**TOWN OF BROOKLYN
 PLANNING AND ZONING COMMISSION
 Regular Meeting Agenda
 Tuesday, October 20, 2020
 6:30 p.m.**

SUBJECT: Proposed Parking Expansion
Vachon Chevrolet
Assessor's Map 41, Lot Nos. 13A & 14
Providence Road (Route 6)
Brooklyn, Connecticut

ENGINEERING PLAN REVIEW PERTAINING TO A 3-LOT SUBDIVISION (ASSESSOR'S MAP 34, LOT 52) PRINCE HILL ROAD BROOKLYN, CT (September 1, 2020)

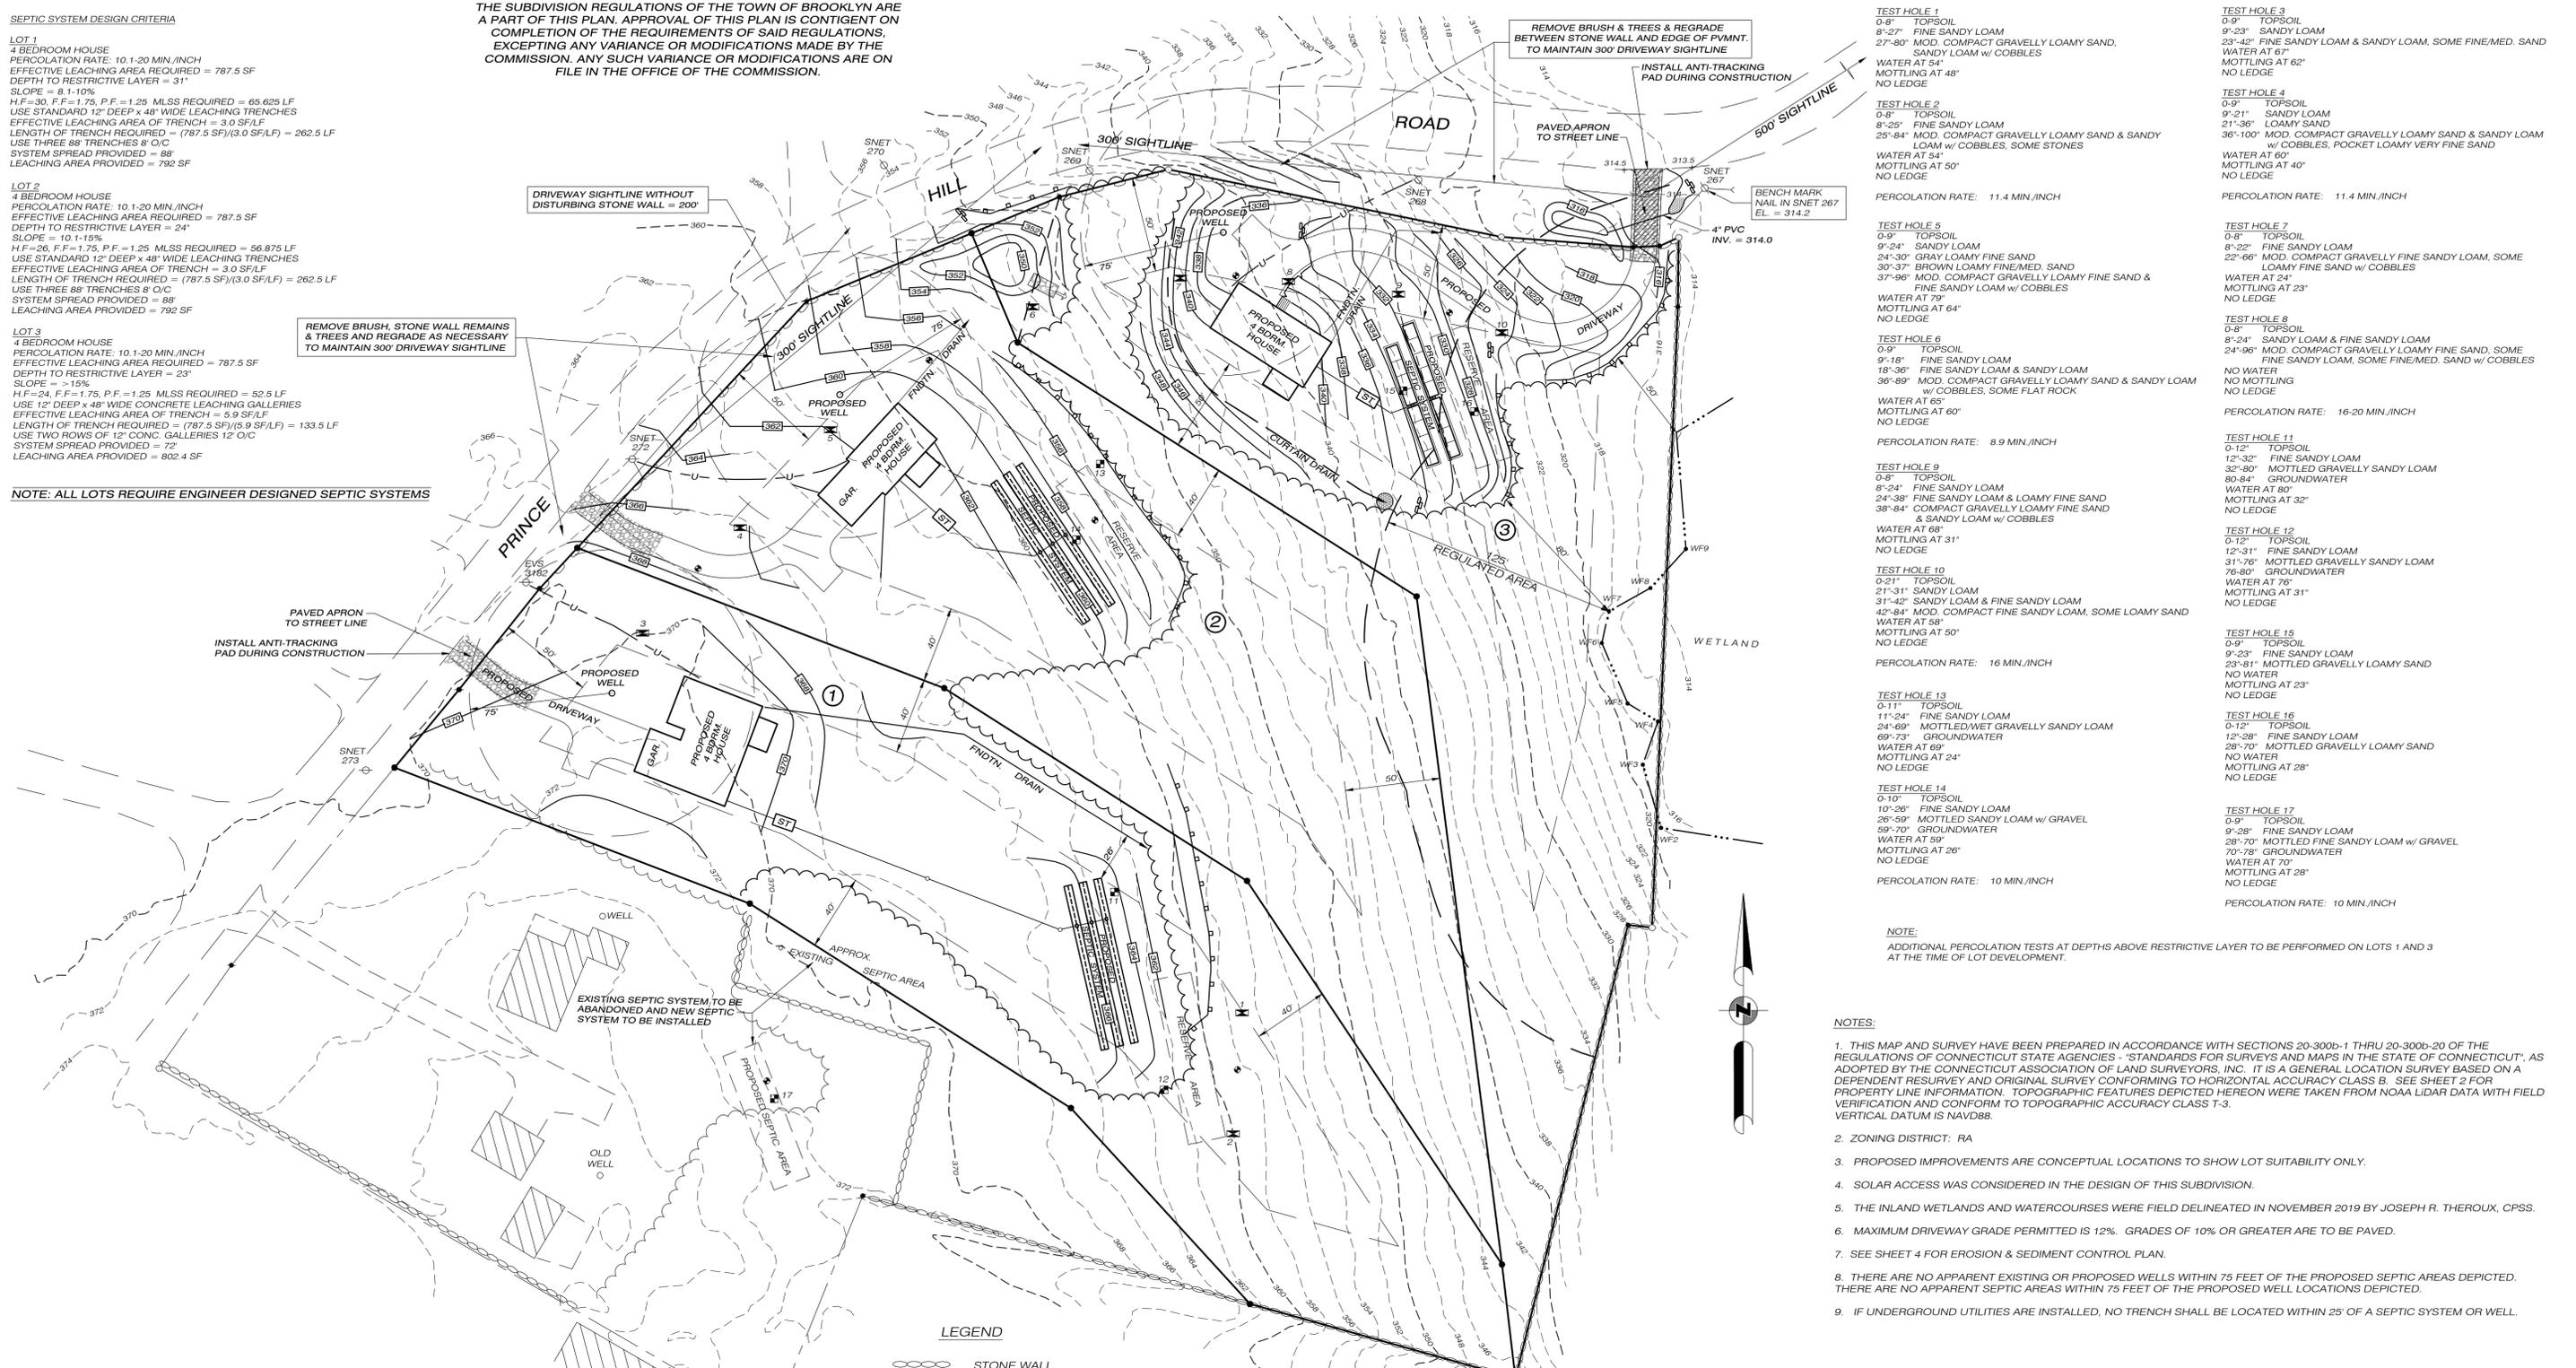
3. On Sheet 3 of 4 there is a note under the test hole data columns stating that "*Additional percolation tests at depths above restrictive layer to be performed on Lots 1 and 3 at the time of lot development.*" As far as I know, the need for this note remains unexplained. The consultant submitted a letter from the Northeast District Department of Health, dated July 20, 2020 and addressed to David and Nancy Bell, regarding the feasibility of future development of their land to be subdivided into three (3) lots with 4 bedroom houses. Said letter makes no mention of performing additional percolation tests and, therefore, I would like an explanation of what this means from the Applicant's consulting professional engineer (engineered septic systems are required).

4. There is no certified soil scientist signature block on Sheet 3 of 4 attesting to the validity of the flag line delineating the wetlands on the subject property.
